APPLICATION NO.	FILING DATE	FIRST NAMED INVENTOR	ATTORNEY DOCKET NO.	CONFIRMATION NO.
10/786,725	02/25/2004	Kirk D. Swenson	3896-031736 (P-6004)	2750
32182	7590	10/11/2006	EXAMINER	
DAVID W. HIGHET, VP AND CHIEF IP COUNSEL BECTON DICKINSON AND COMPANY [THE WEBB LAW FIRM] FRANKLIN LAKES, NJ 07414-1880			TOWA, RENE T	
		ART UNIT		PAPER NUMBER
				3736

Office Action Summary	Application No.	Applicant(s)
	10/786,725	SWENSON ET AL.
	Examiner Rene Towa	Art Unit 3736

DETAILED ACTION

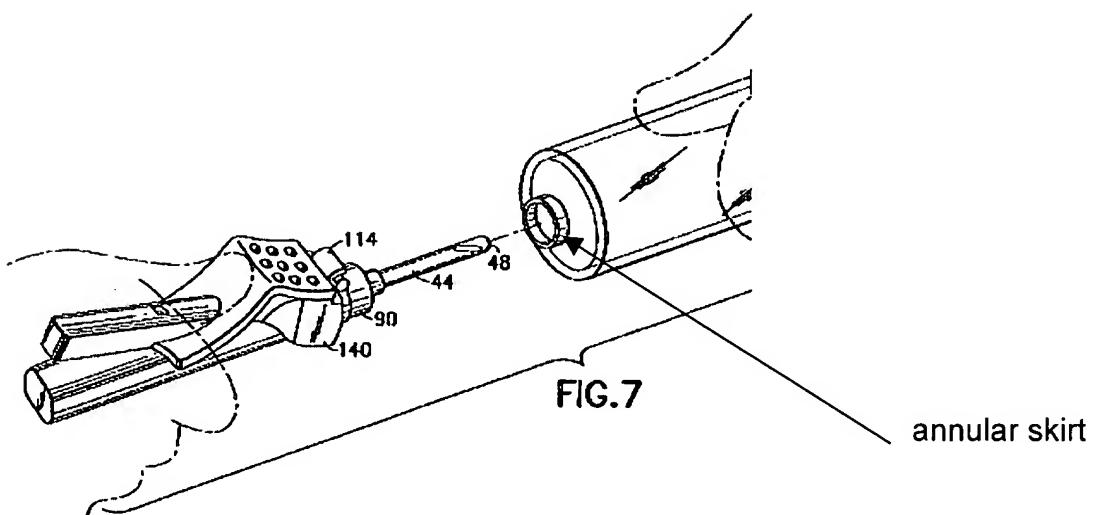
9. Applicant's arguments filed July 20, 2006 have been fully considered but they are not persuasive. Applicant argues that Newby et al. (hereinafter Newby) fails to disclose a device wherein a safety shield and a collar can be radially rotated to a desired position

around the axis without the axial movement of the collar along the axis. This argument has been considered and has not been deemed persuasive.

In regards to the Applicant's argument that Newby fails to teach to disclose a device wherein a safety shield and a collar can be radially rotated to a desired position around the axis without the axial movement of the collar along the axis, the Examiner respectfully disagrees. As better depicted in figure 7, Newby discloses a device that comprises an annular skirt attached to the housing and a safety shield and a collar can be radially rotated to a desired position around the axis without the axial movement of the collar along the axis (see illustration below, see rejections supra).
